**Comments of GE Transportation on California Air Resources Board's  
Draft Technology Assessment for Freight Locomotives  
Submitted June 15, 2016**

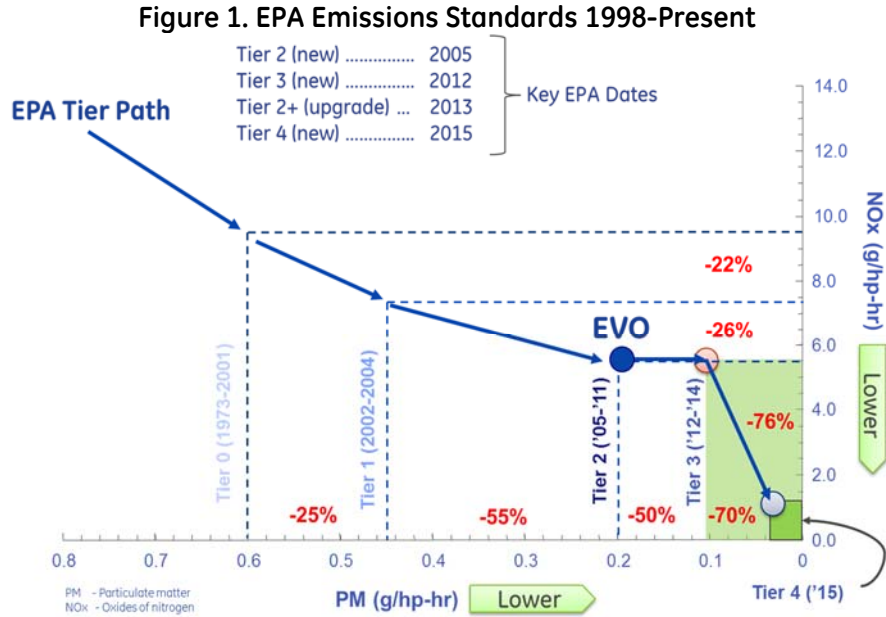
As ARB's Draft Technology Assessment notes, emissions from locomotives are regulated by the U.S. EPA, and the standards have become significantly more stringent over the last 20 years. These standards focus on emissions of nitrogen oxides ("NOx") and particulate matter ("PM").<sup>1</sup> The first set of U.S. EPA emissions standards (promulgated in 1998) required that, beginning in the year 2000, new locomotives meet the Tier 0 NOx standard of 9.5 grams per brake horsepower per hour ("g/bhp-hr") and a PM standard of 0.60 g/bhp-hr. Today's Tier 4 emissions standards require new locomotives to meet a NOx standard of 1.3 g/bhp-hr and a PM standard of 0.03 g/bhp-hr. The figure below (also indicating the introduction of GE's first Evolution series locomotive in 2005) shows the increased stringency of locomotive emissions standards over time.
